**Presentation on the Jackson Bluff Dam Spillway Project**

**RE: Surface Water Management Application 04-2009-0006 I**  
**Jackson Bluff Dam Spillway Modification – Gadsden County**

Re: City of Tallahassee – Corn Hydroelectric Generating Facility  
Spillway Modification Project – Application 04-2009-0006 I  
Request for Information dated October 19, 2009

RE: City of Tallahassee – Corn Hydro Spillway Modification  
Application 20-0296182-001-DF - Request for Additional Information – Item #3

City of Tallahassee  
 C. H. Corn Hydro Facility  
 Attachment 4 - Hydrographs for 500-Year Flood Condition  
 Fuse Plug Breaches Deeper

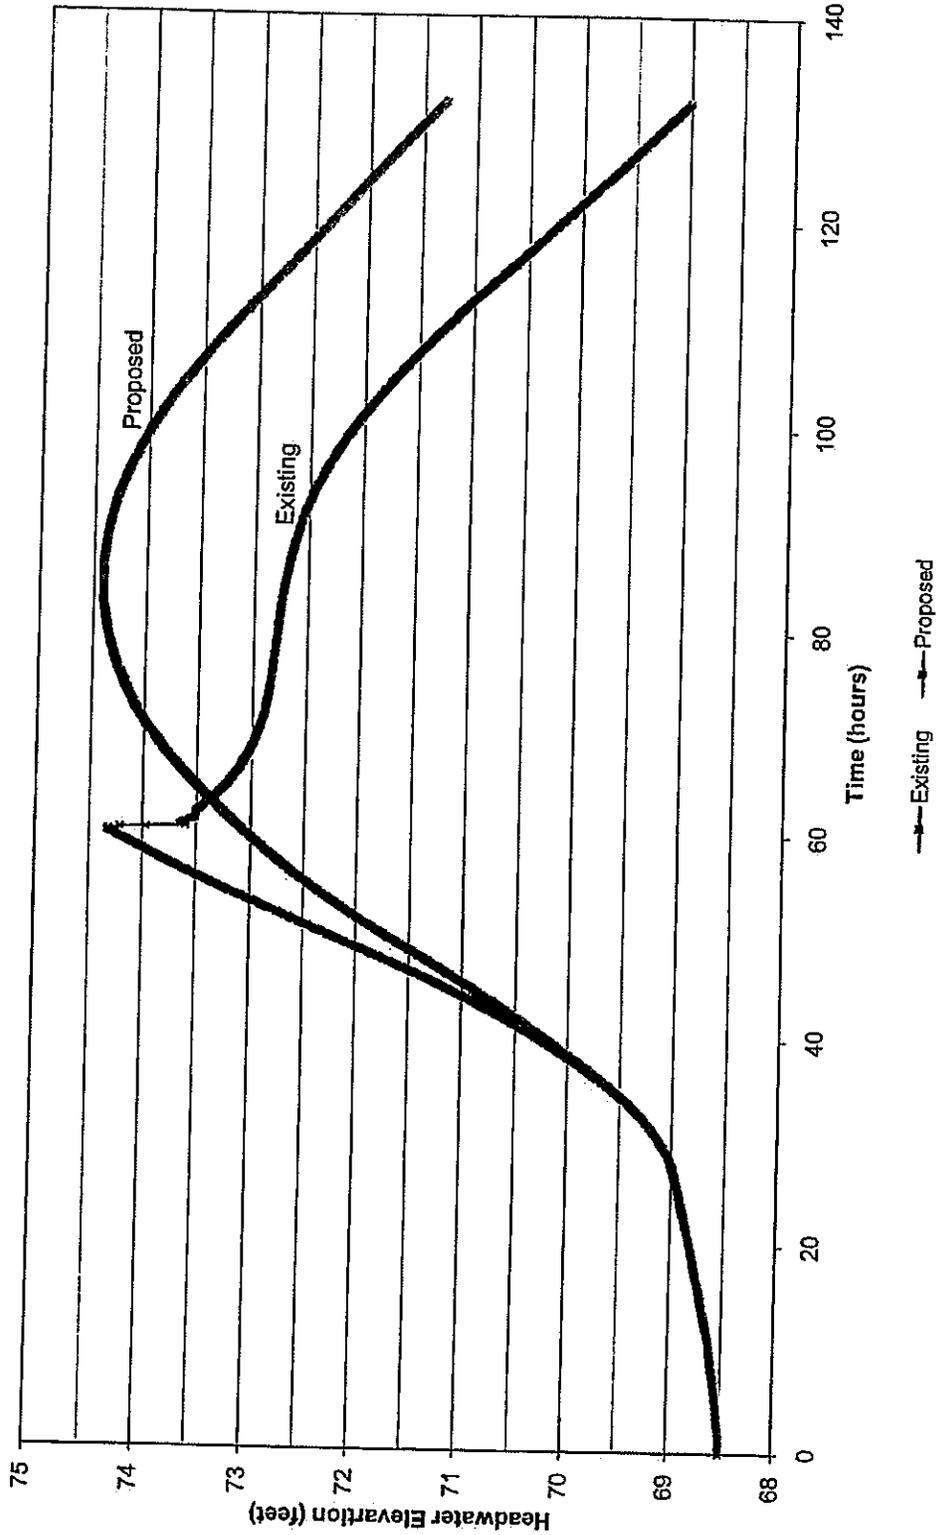
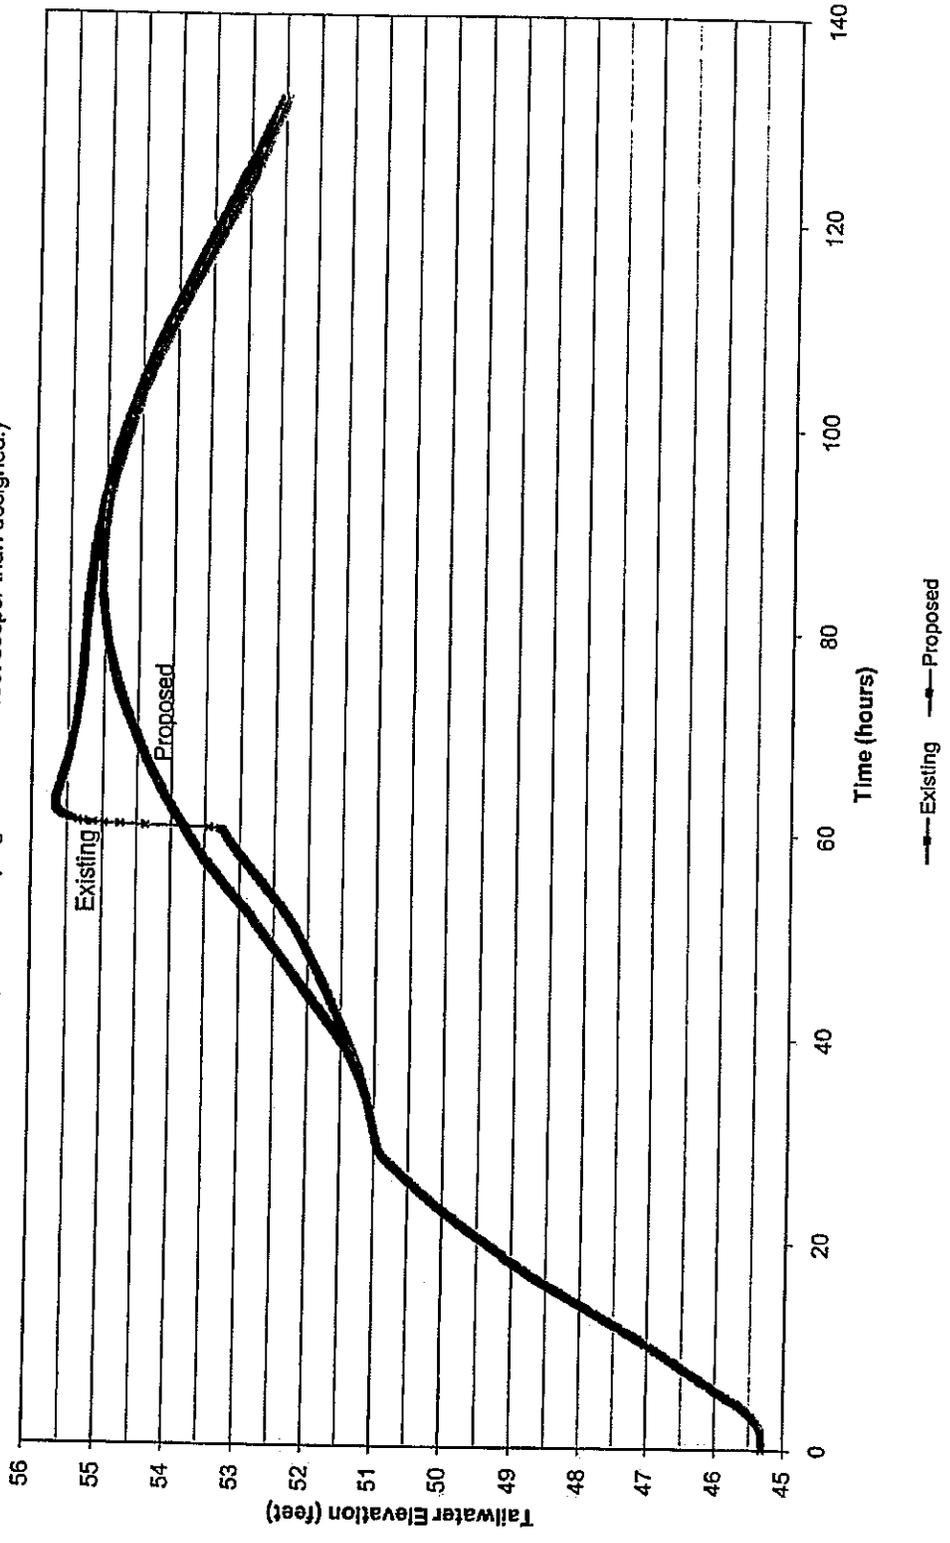
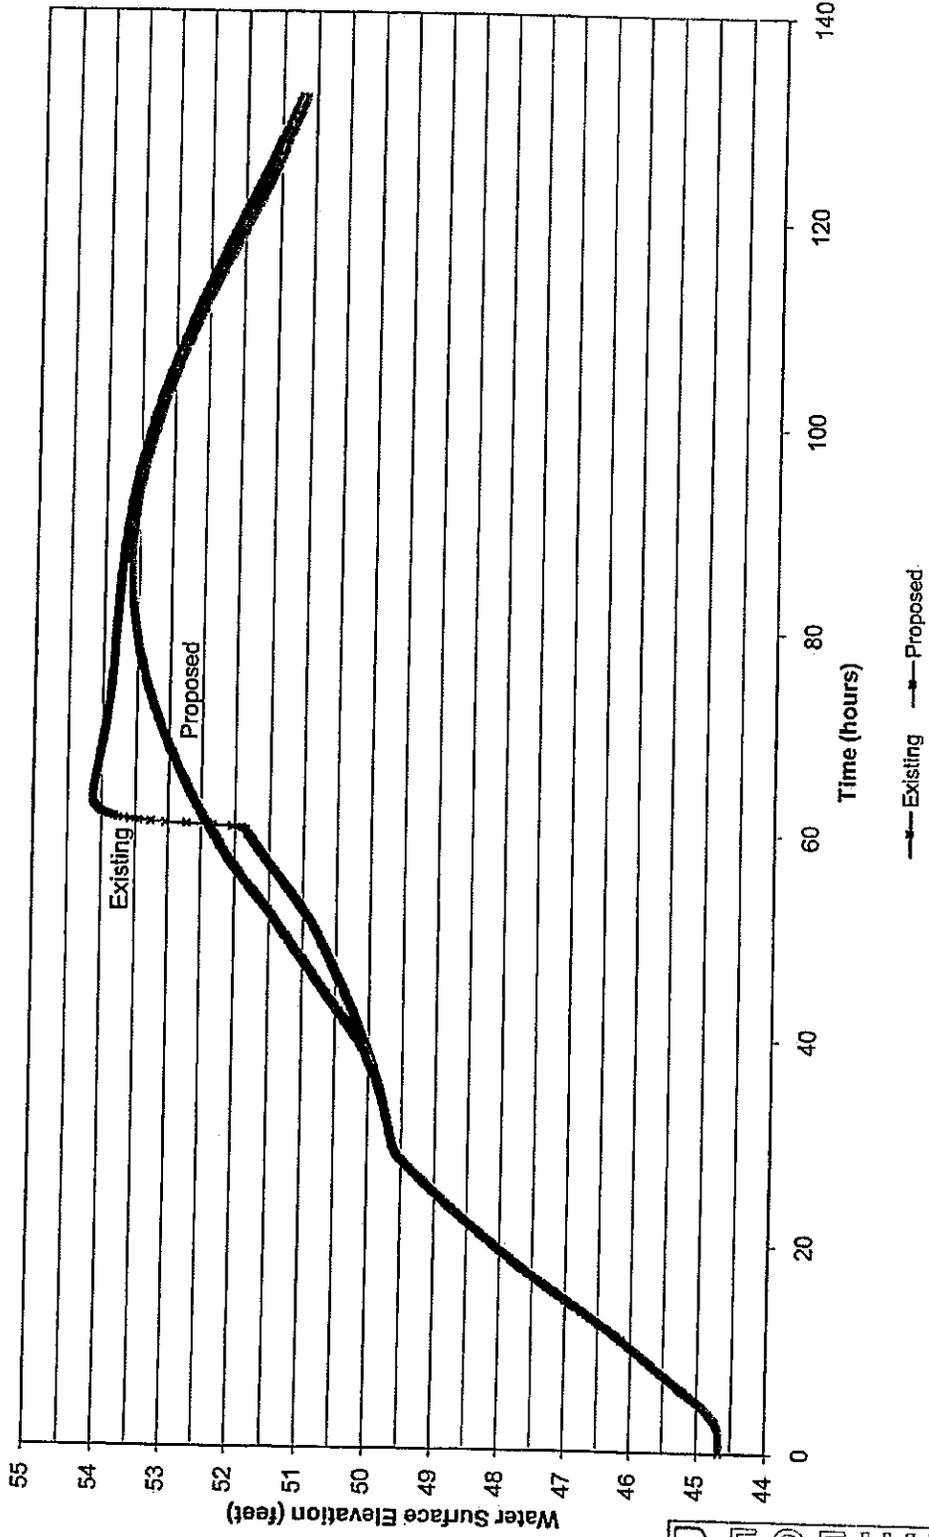
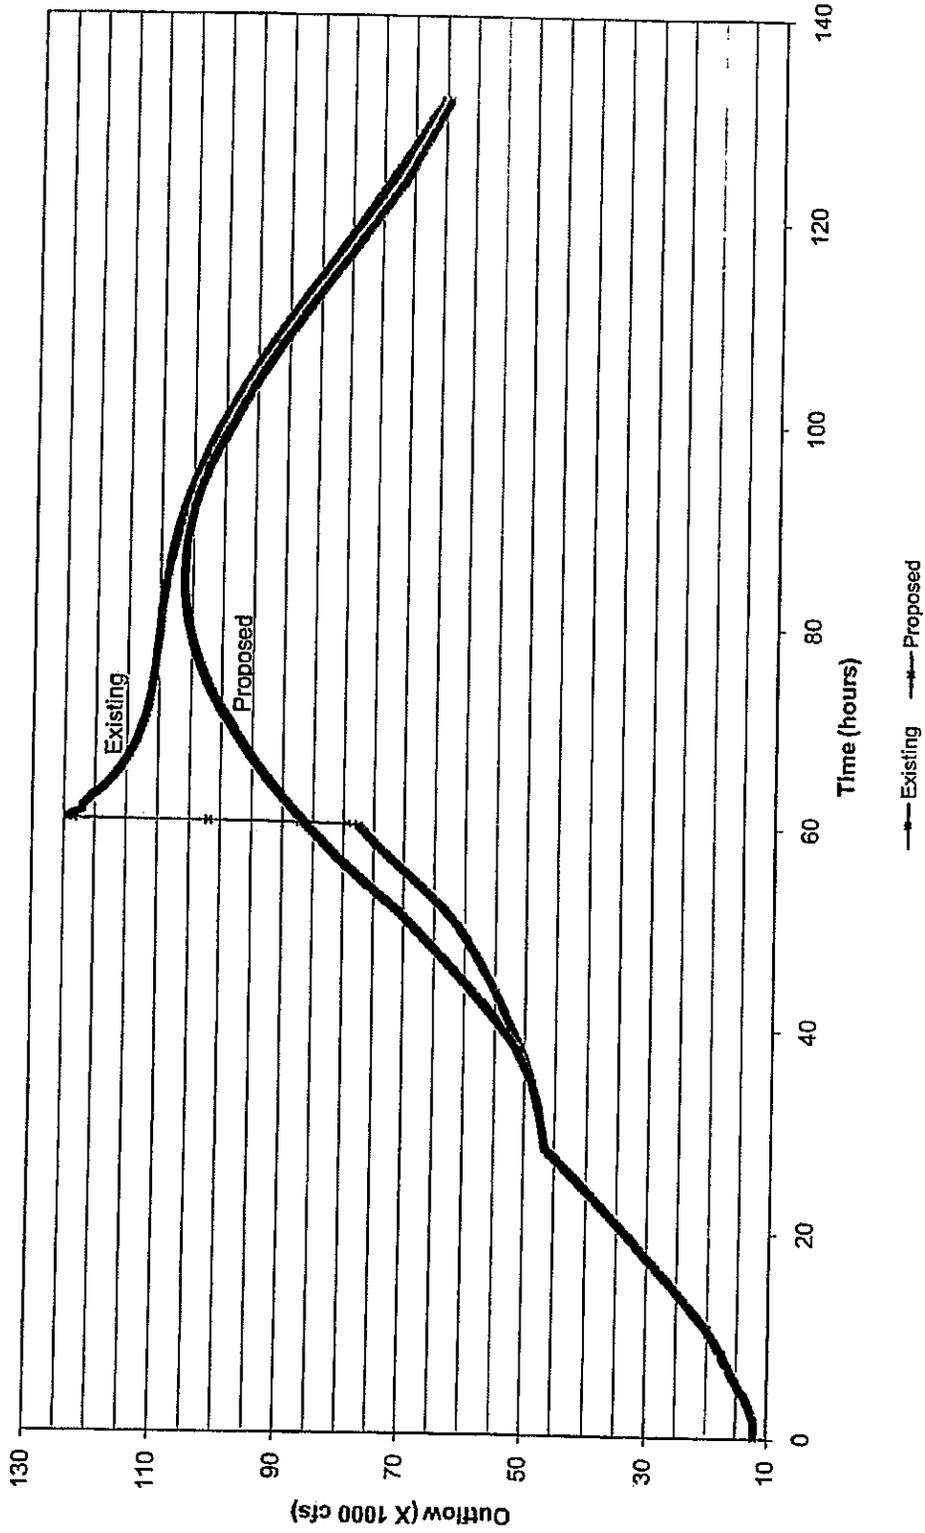
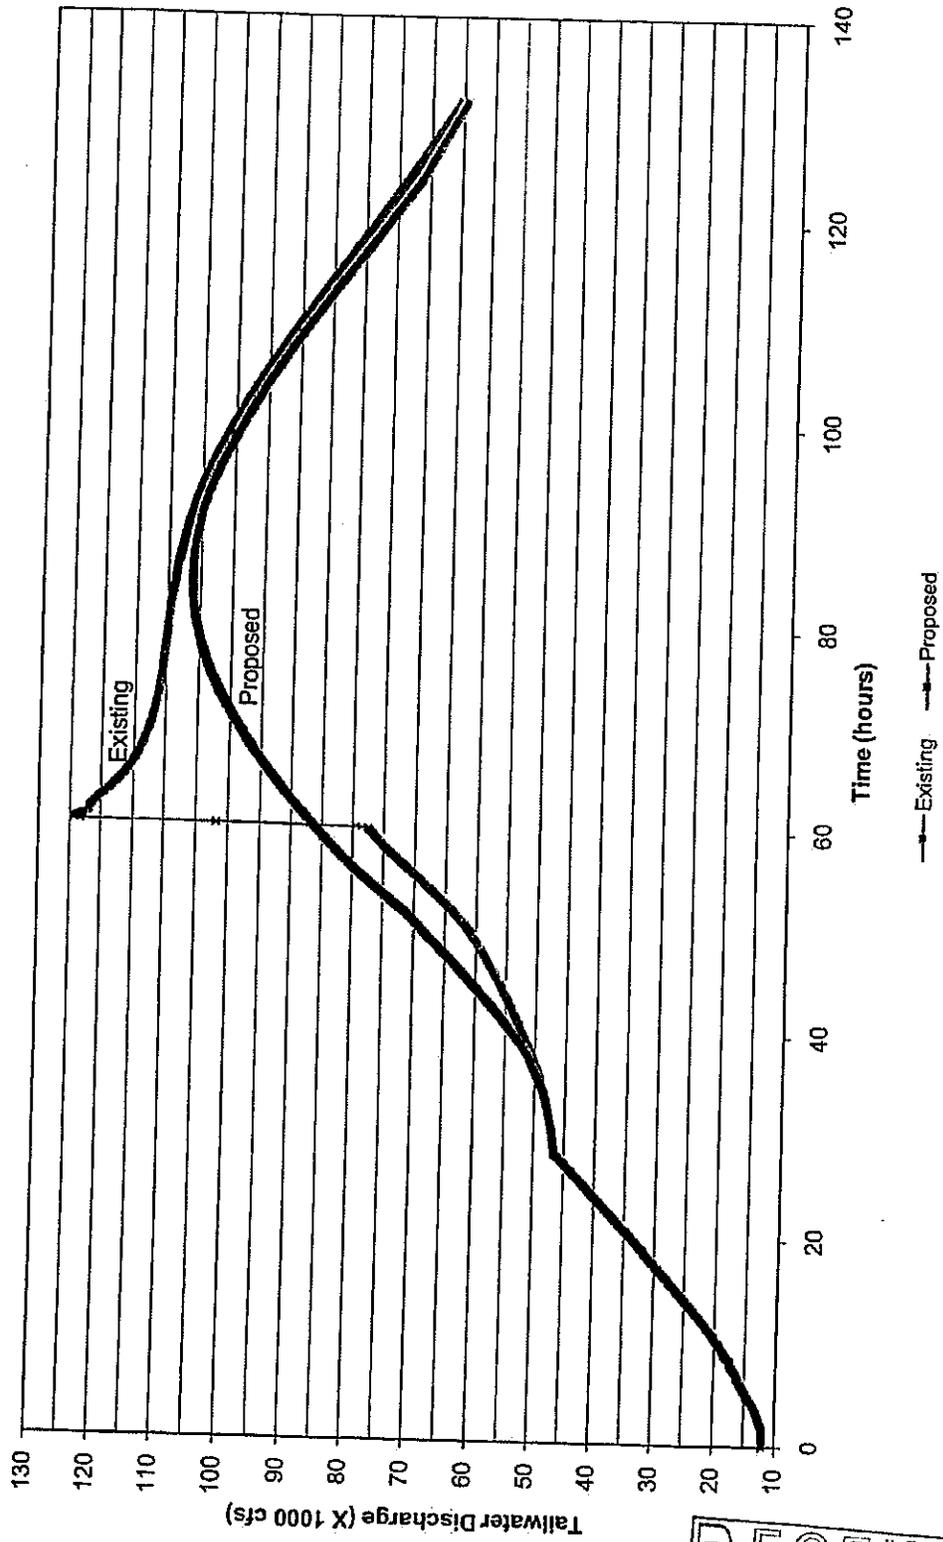
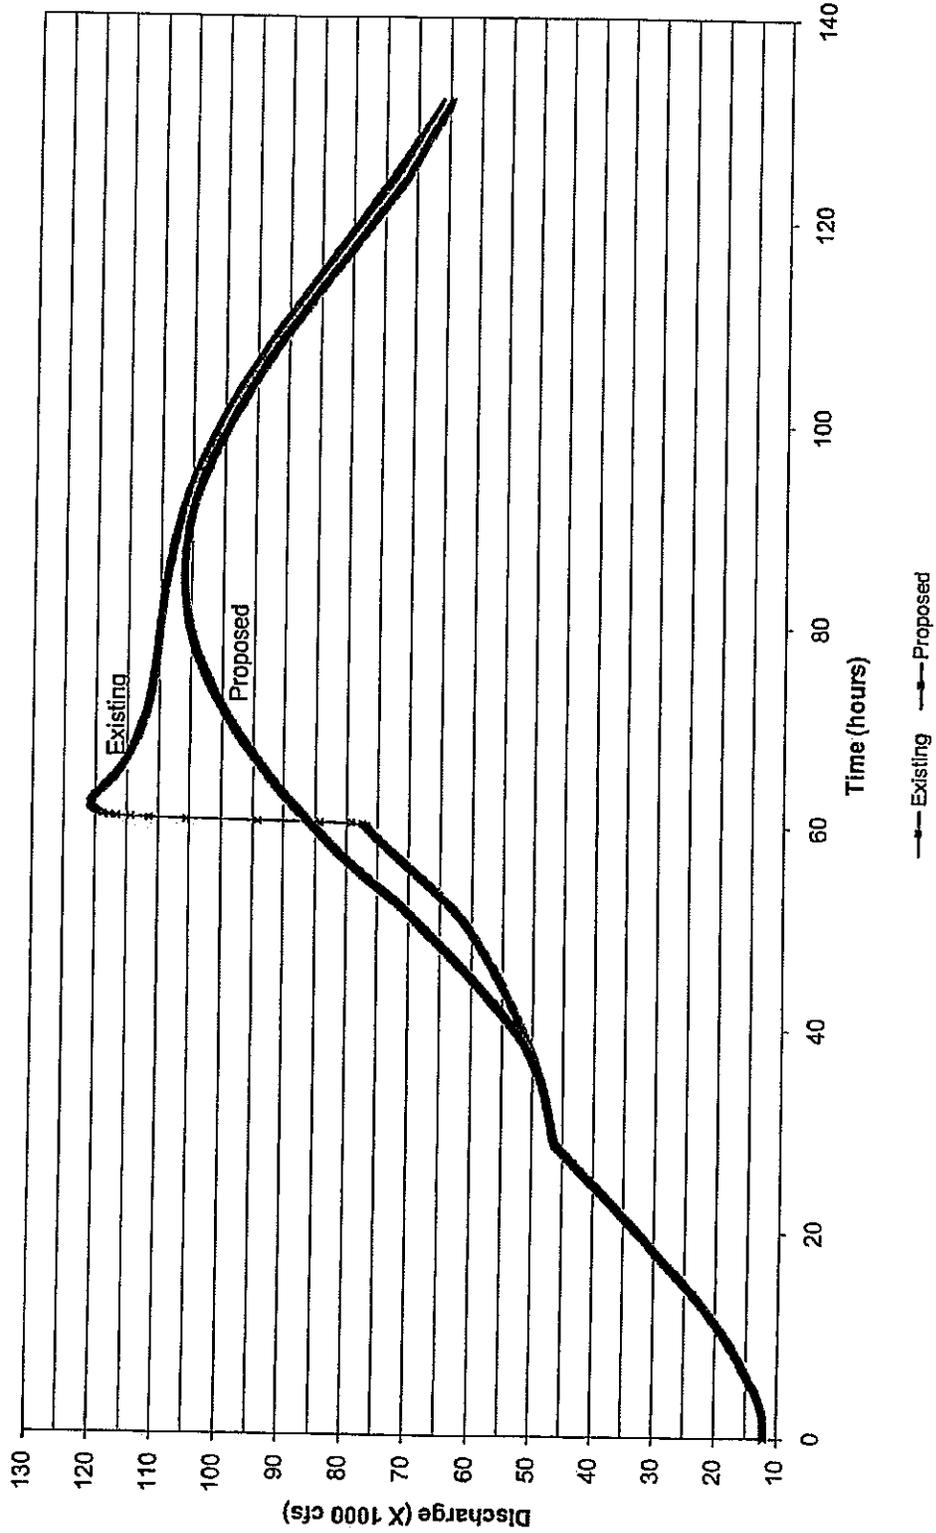
As you know, we recently received an objection letter concerning your project's proposed lowering of the spillway. Please provide a letter clearly stating and justifying that the lowering of the existing invert of the spillway by 2.5 feet will not increase the potential for flood damage to the houses downstream of the dam.

The fuse plug spillway is overtopped at the 500-year flood. Attachment 4 shows the water surface elevation and flow versus time under the 500-year flood, assuming the fuse plug spillway fails 4 feet deeper than its designed level of 68.3 feet. The graphs in Attachment 4 show that the downstream river level for the existing condition will be approximately 0.5 feet higher than that for the proposed design, if the fuse plug fails deeper than designed. The flow for the existing condition will be over 20,000 cfs higher than that for the proposed condition.
